ADDENDUM NO. 03

Date: June 4, 2024

Project: Conway Corporation
Roger Q Mills Jr.
Water Treatment Plant 8 MGD Expansion & Improvements

The Contract Documents dated May 3, 2024, and Addendum No. 02 issued May 28, 2024, are hereby amended as follows:

DESIGNED: CAJ	CRIST JOB NO. 2135	DATE	ADD. NO.
DRAFTED: MAB	GARVER JOB NO. 19W01300	6/03/24	3
CHECKED: CAJ	SCALE: NOT TO SCALE		REF SHEET 05-X301

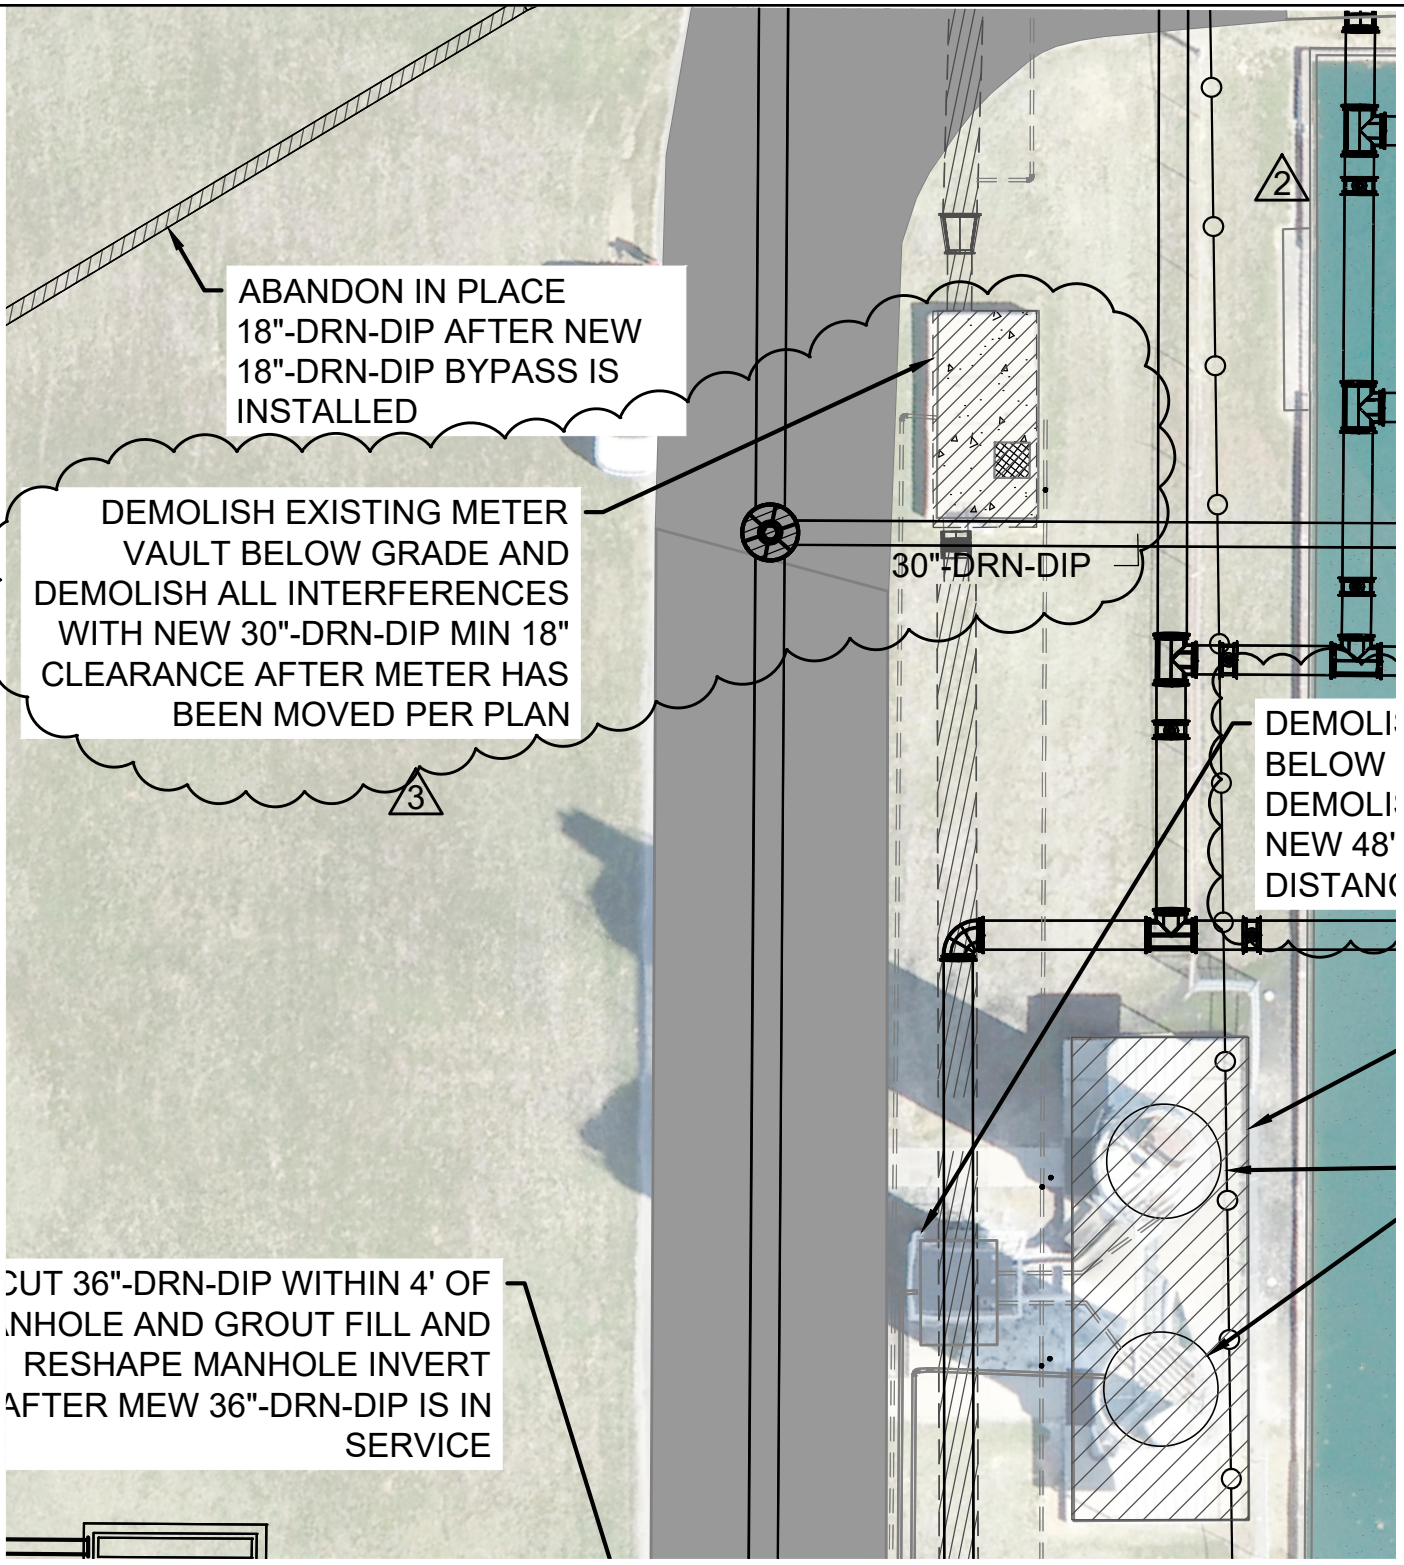
2. Drawing 05-X301 (Sheet No. 20)
    a. Modify the Yard Piping Demolition Plan as shown on the Misc. Yard Piping Demolition 2 – Addendum No. 03, attached hereto.

OVERALL YARD PIPING 1

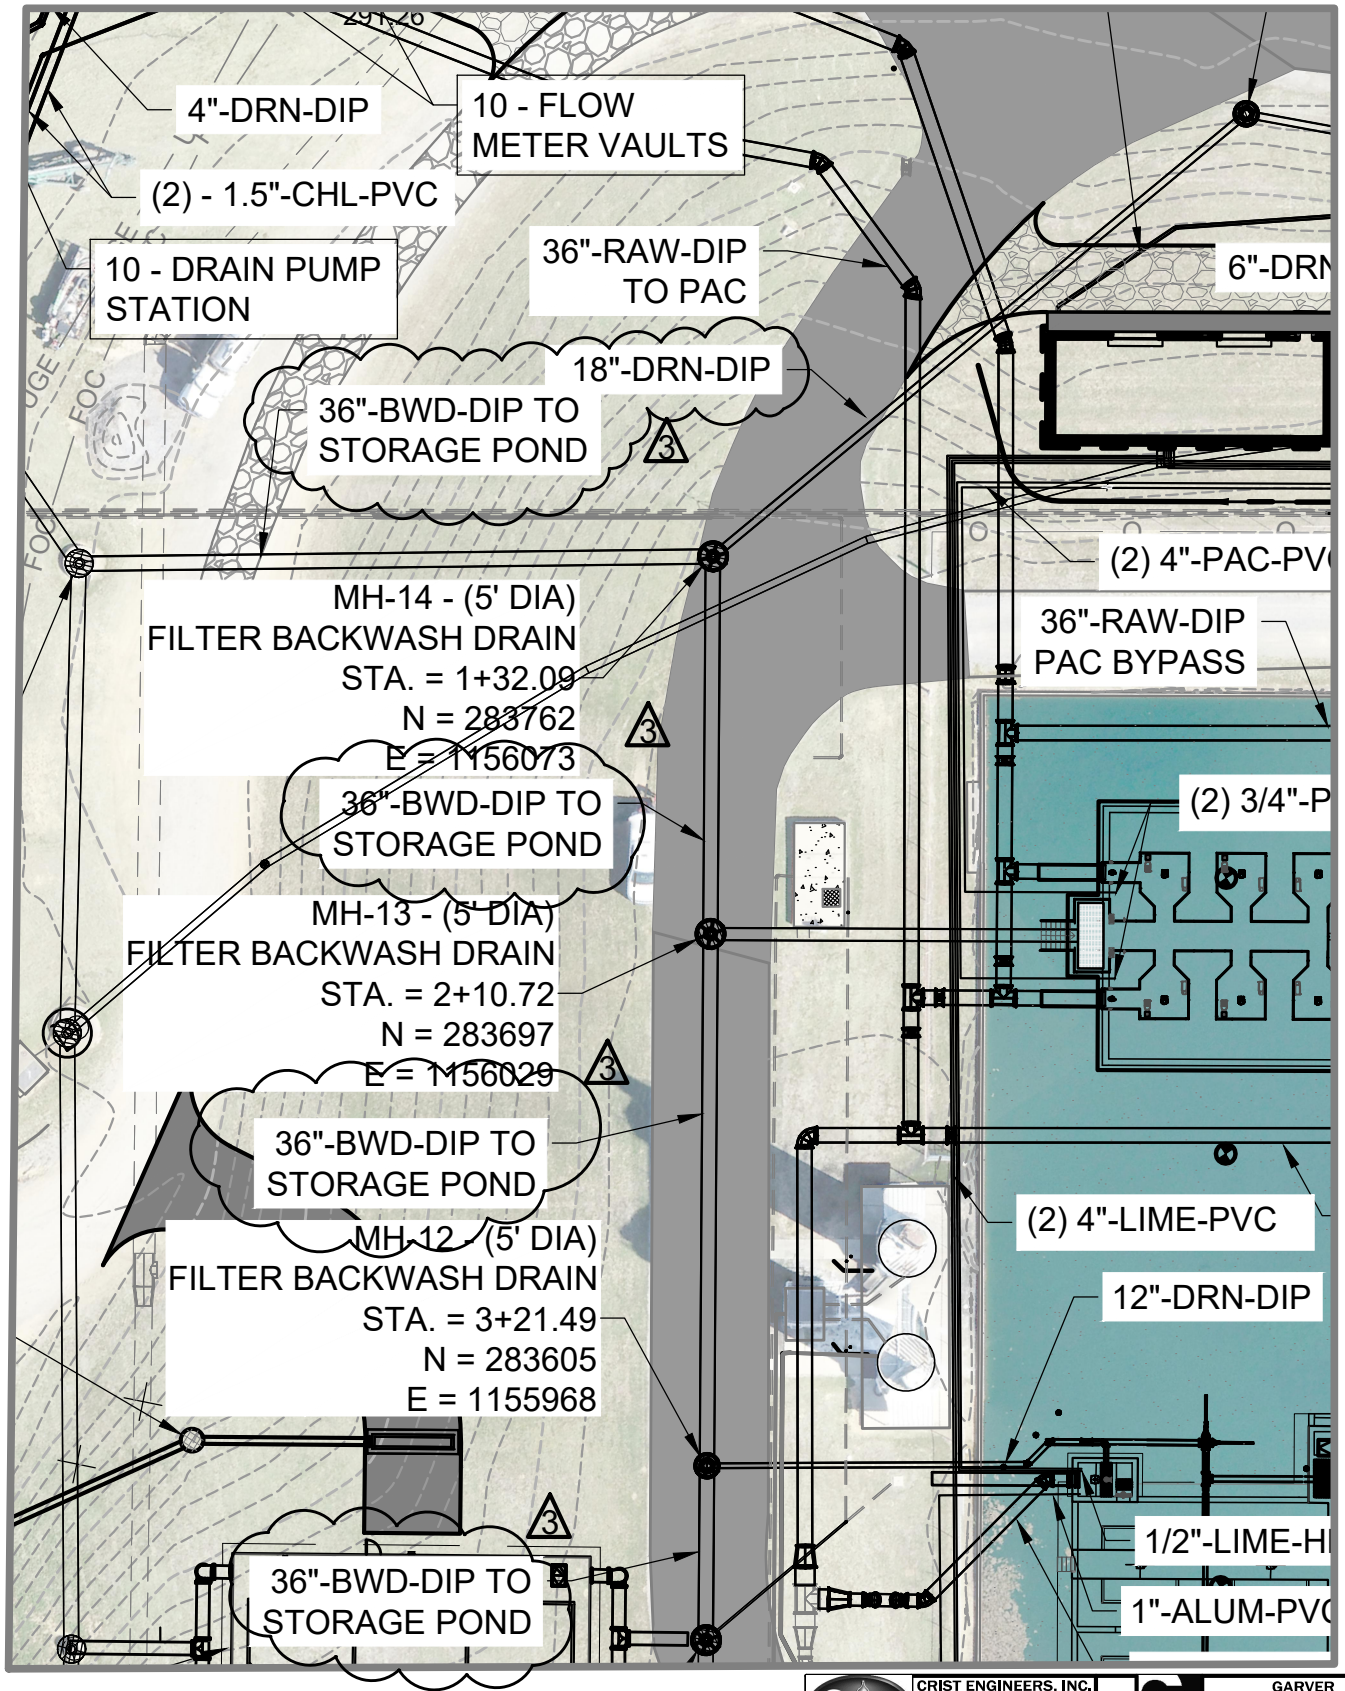
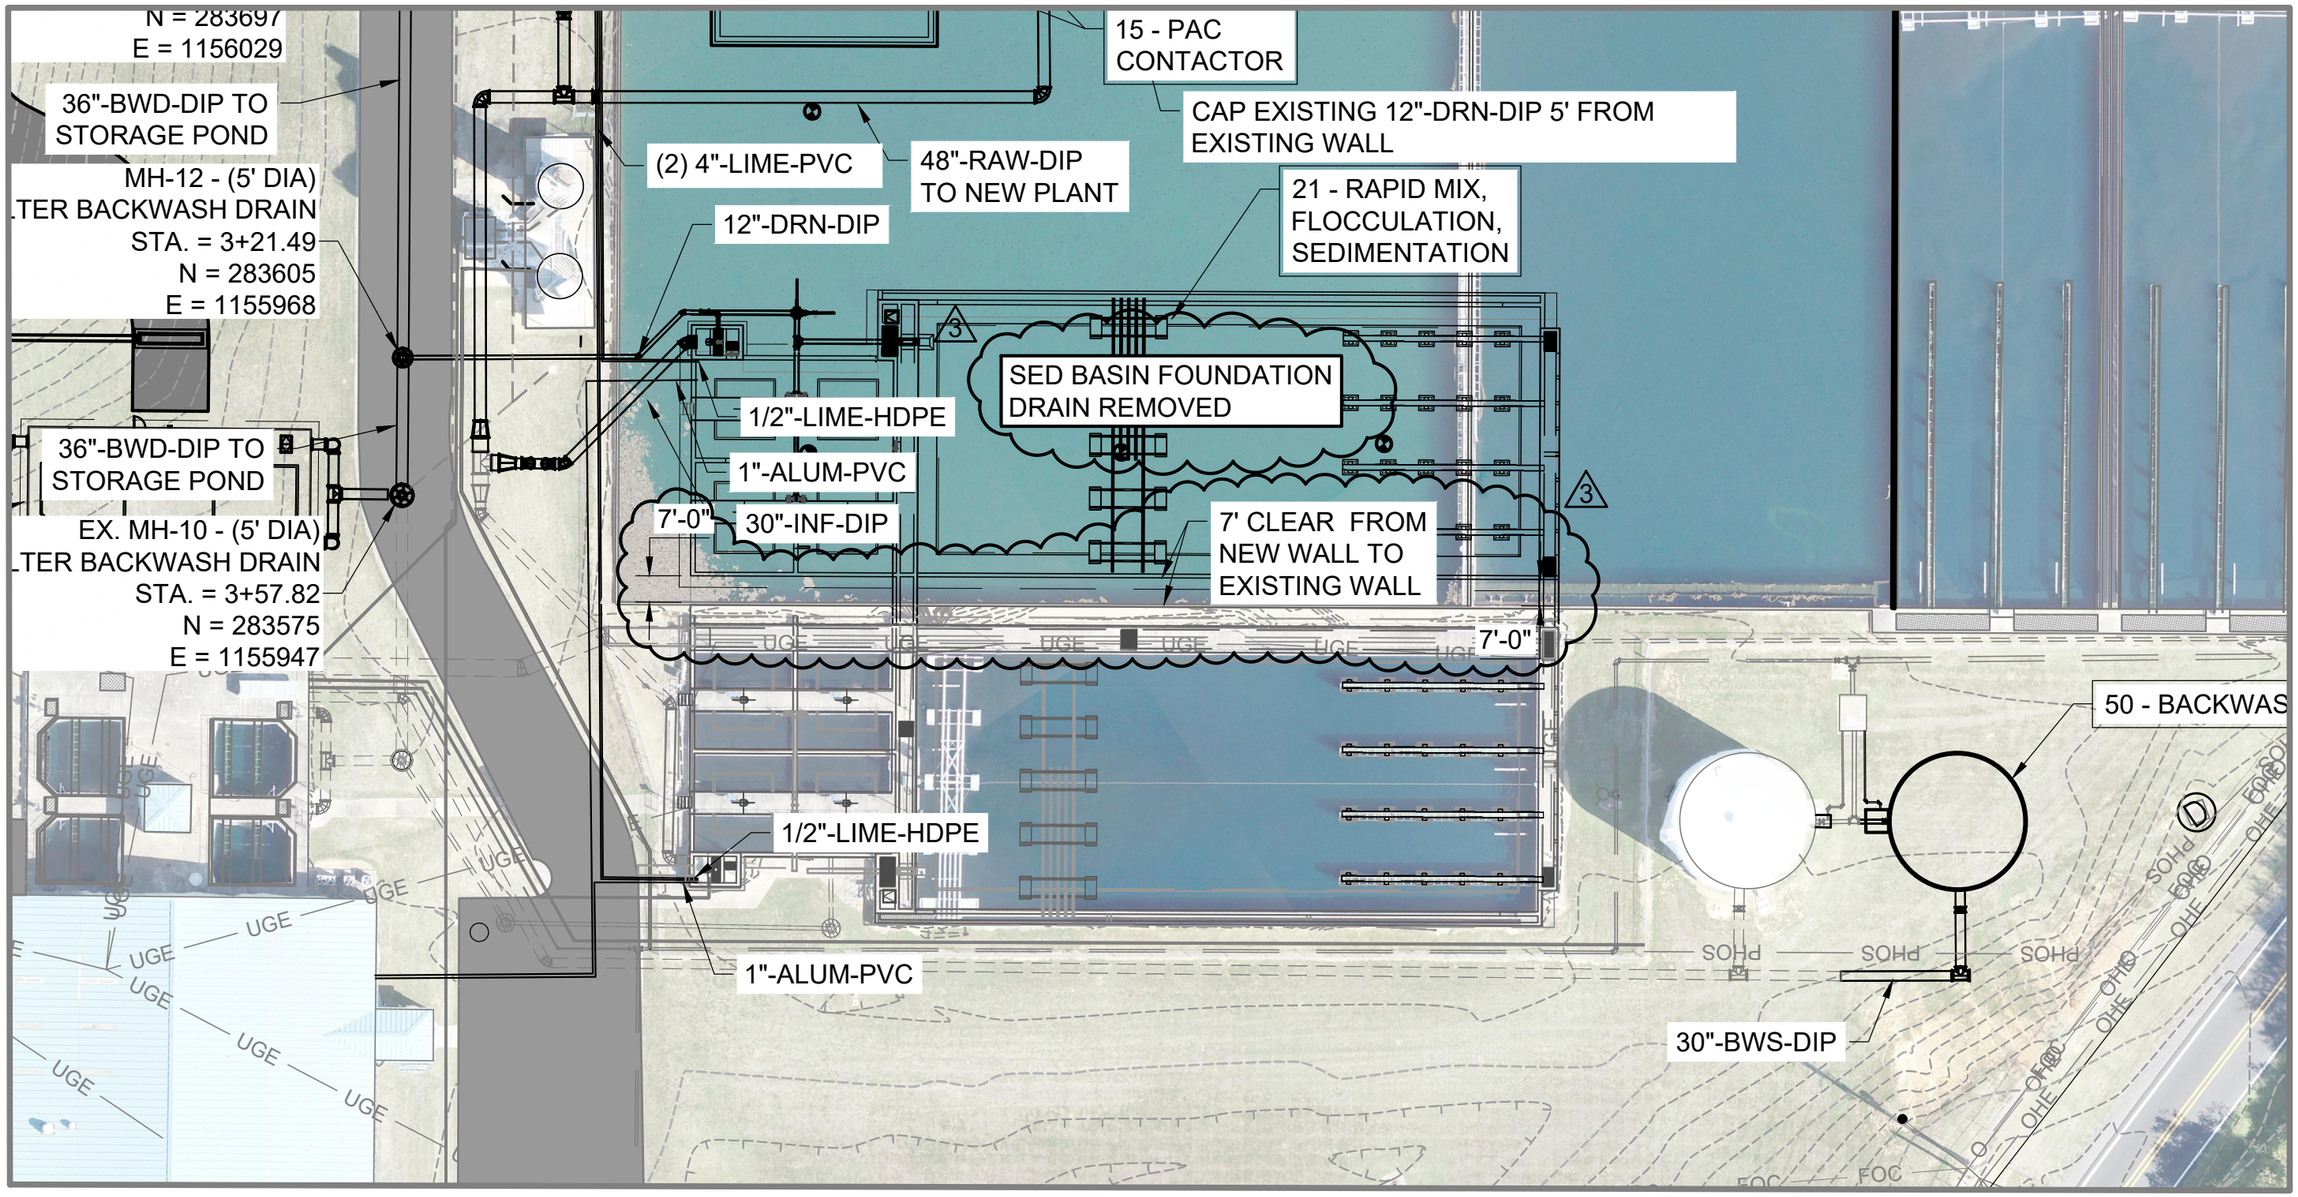
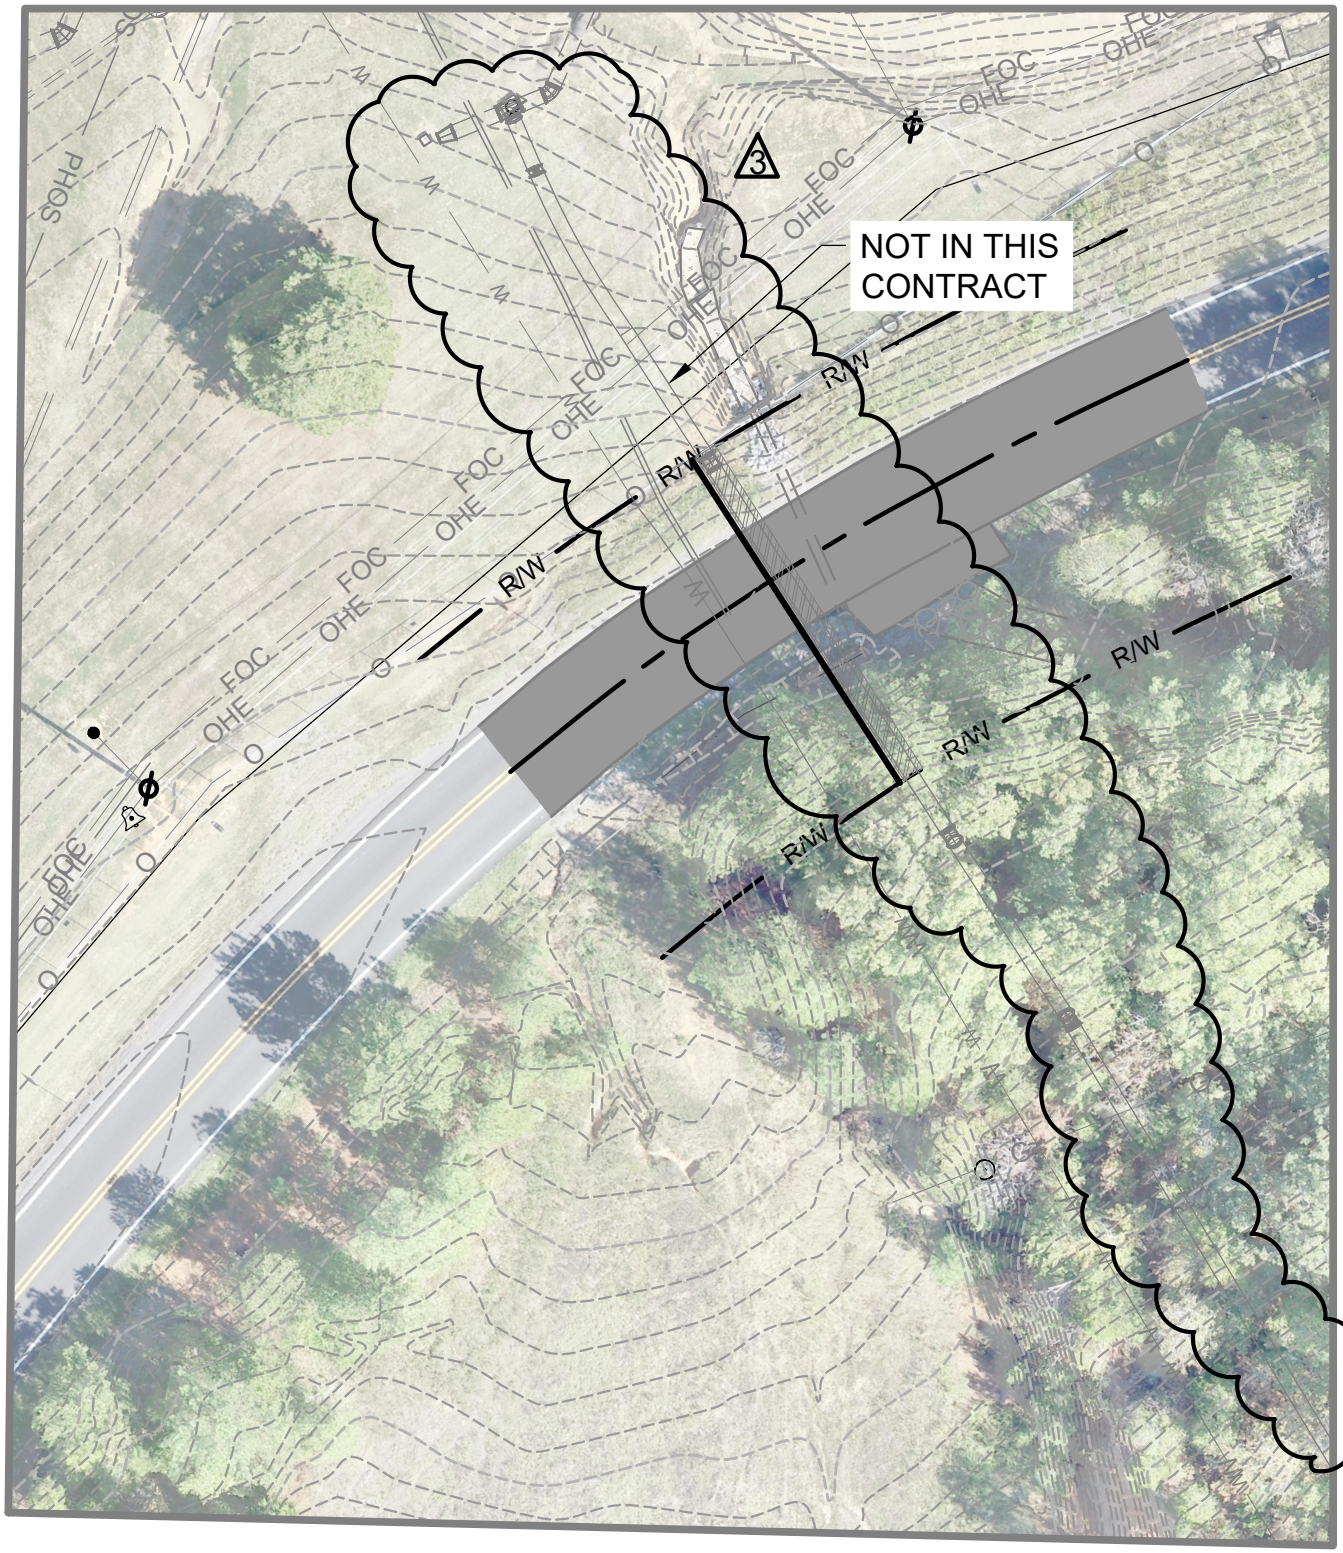
a. Modify the Overall Yard Piping 1 plan as shown on Overall Yard Piping 1 – Addendum No. 03, attached hereto. (Two 8.5 x 11; One 11x17 – Three Drawings)

DESIGNED: CAJ	CRIST JOB NO. 2135	DATE	ADD. NO.
DRAFTED: MAB	GARVER JOB NO. 19W01300	6/03/24	3
CHECKED: CAJ	SCALE: NOT TO SCALE		REF SHEET 05-C103

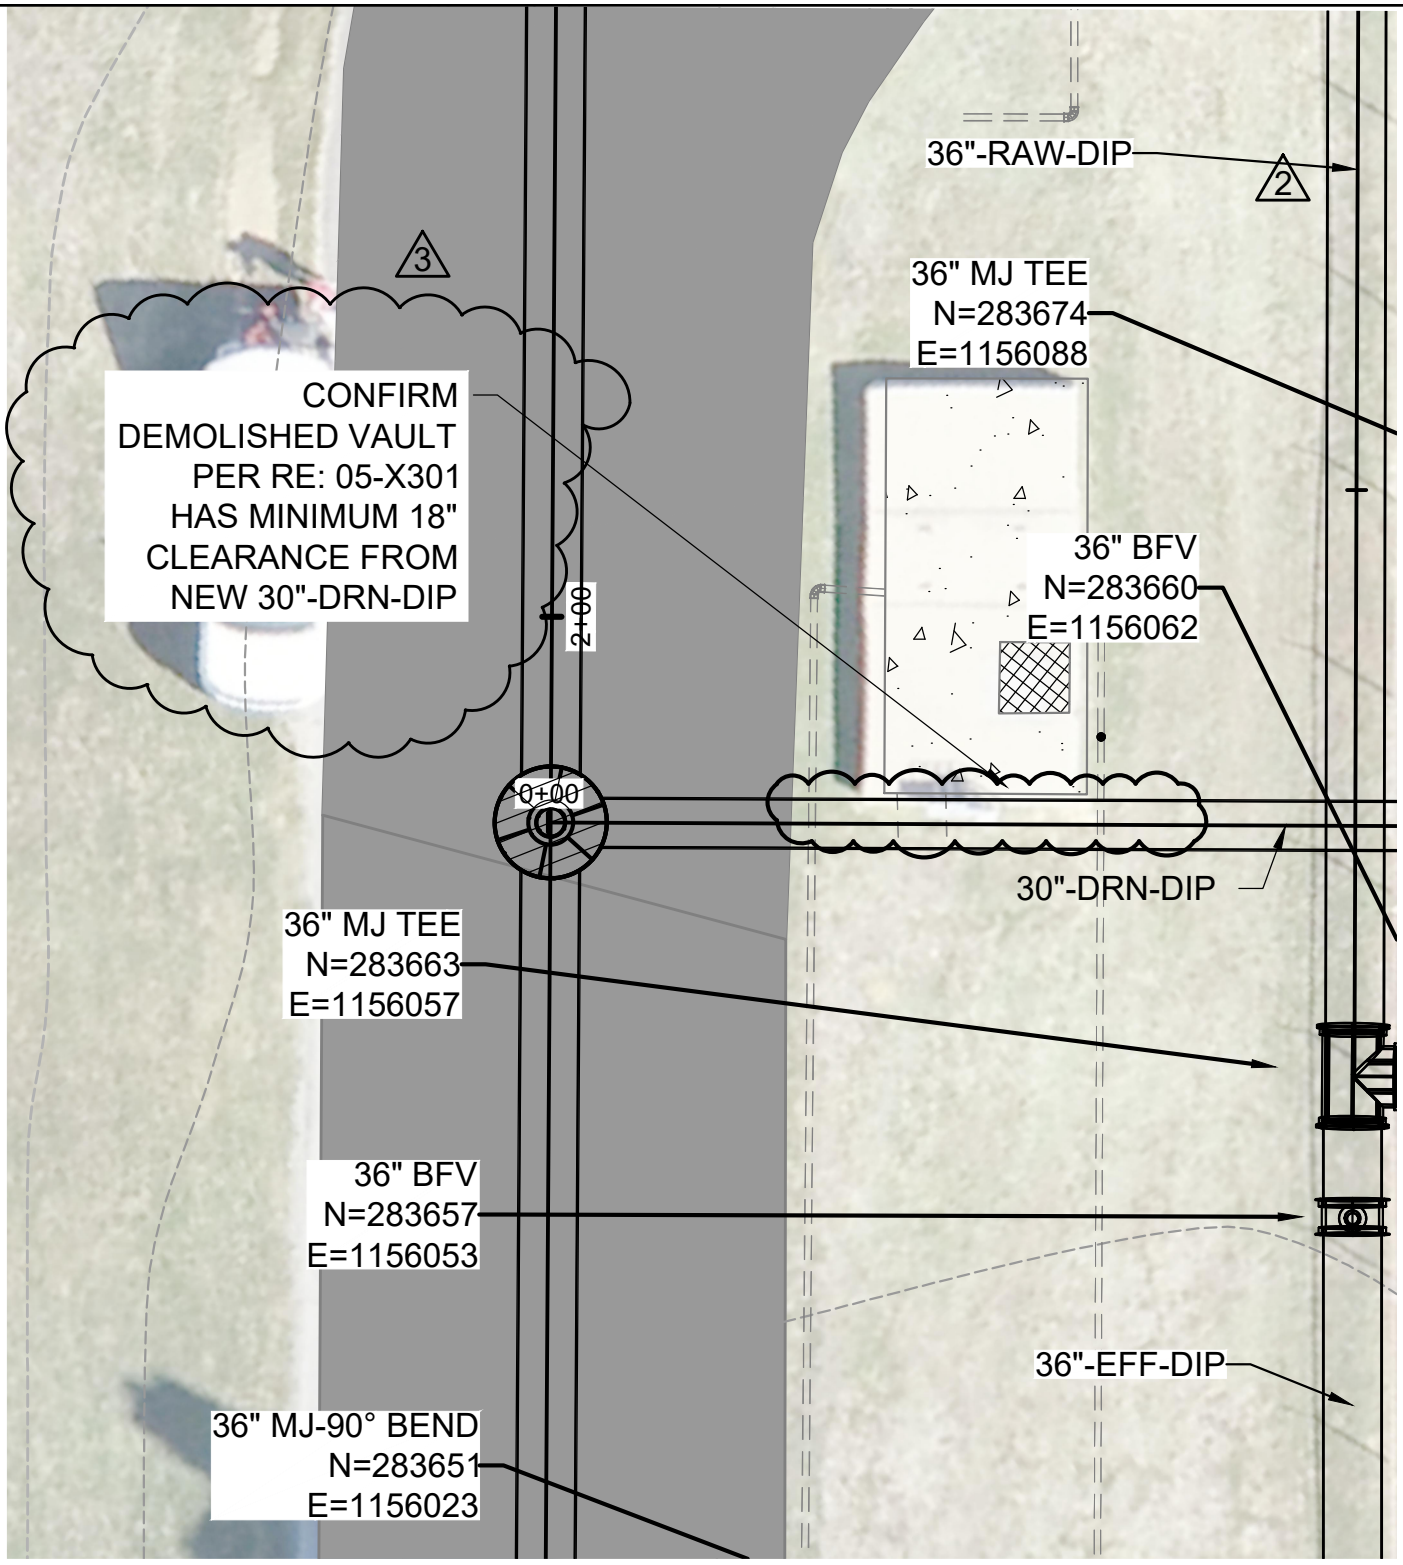
4. Drawing 05-C103 (Sheet No. 23)
   a. Modify the Yard Piping Demolition Plan as shown on Overall Yard Piping 2 – Addendum No. 03, attached hereto.
